## 8A Miscellaneous Electrical Systems

The information in this appendix of the reference ABWR DCD, including all Subsections and figures, is incorporated by reference with the following departures and supplements.

**Figure 8A-1 Site Plan (Grounding)**

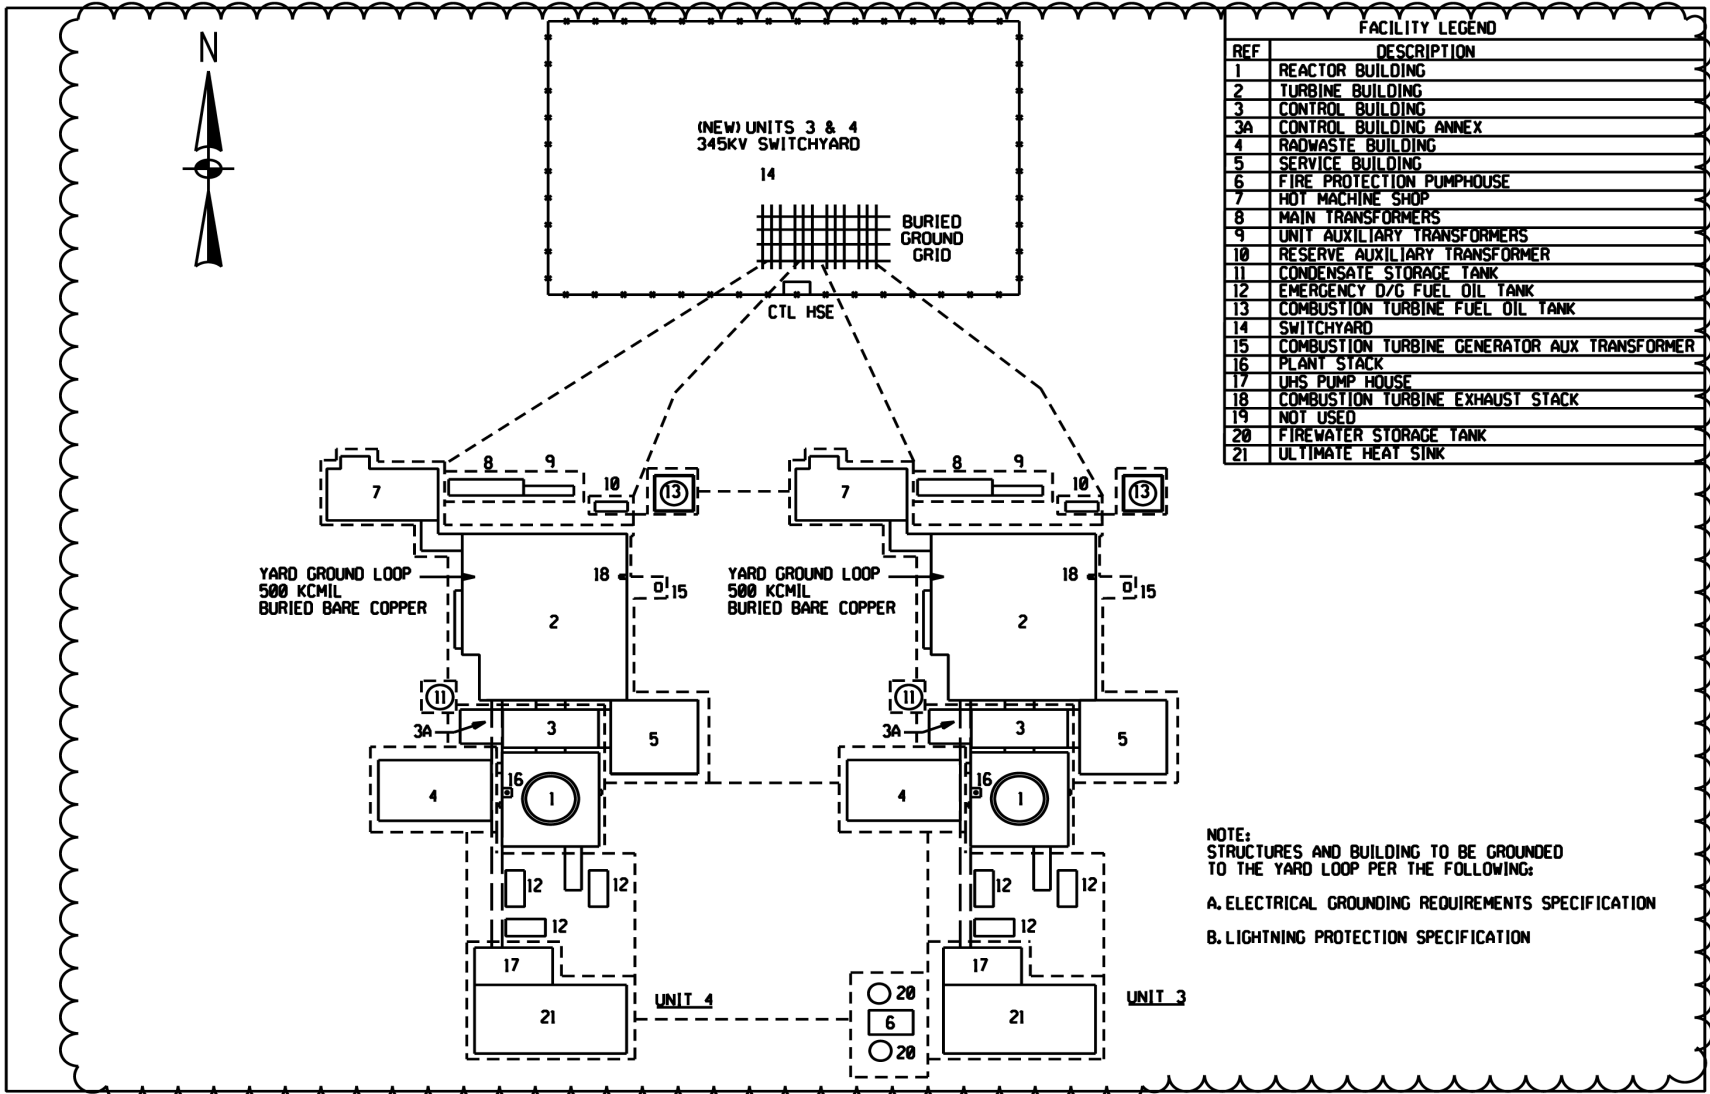
STP DEP 1.1-2 (Figure 8A-1)

STP DEP 1.1-2

- (3) A plant grounding grid shared between STP Units 3 & 4
